Confidentiality	Normal
Doc. no	V66i_SS_2005_08
Date	2005-08-17
Version	1.0

The differences between V66i and V66

Company : ASUSTEK Computer Inc.

➤ The schematic

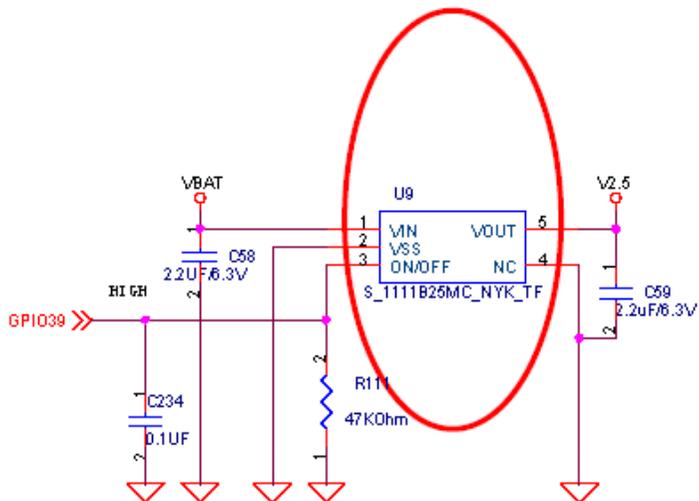
V66

U13 : S-1111B18MC

U9 : S-1111B25MC

V66i

U13 : S-1111B28MC

U9 : S-1111B28MC

➤ The PCB layout

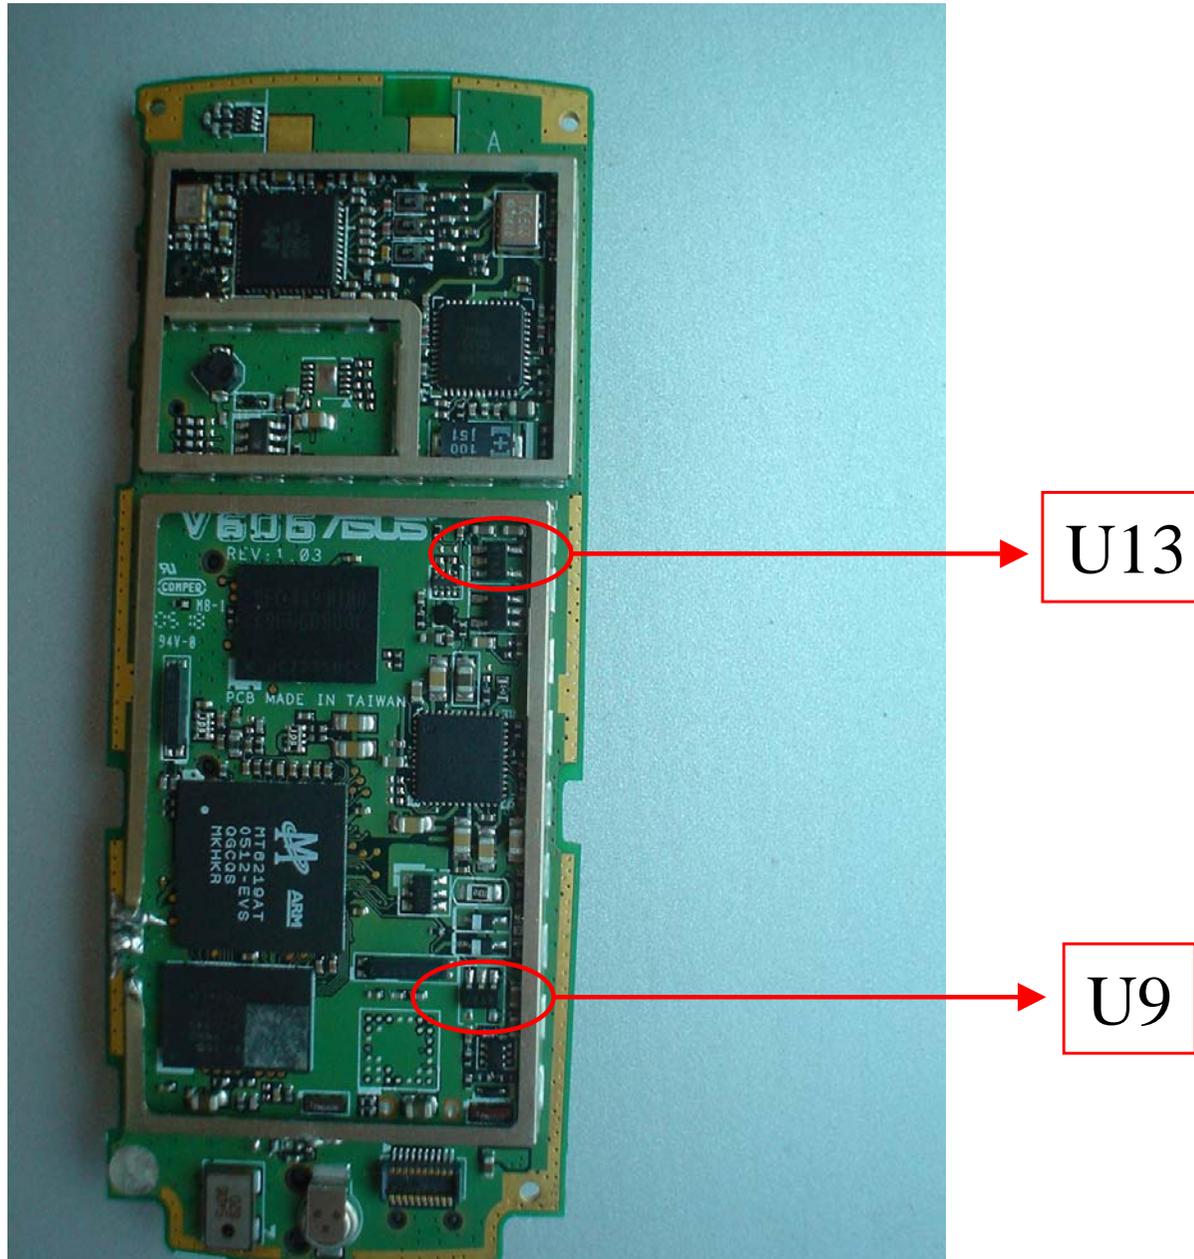
No modify anything, just only exchange component U13 and U9
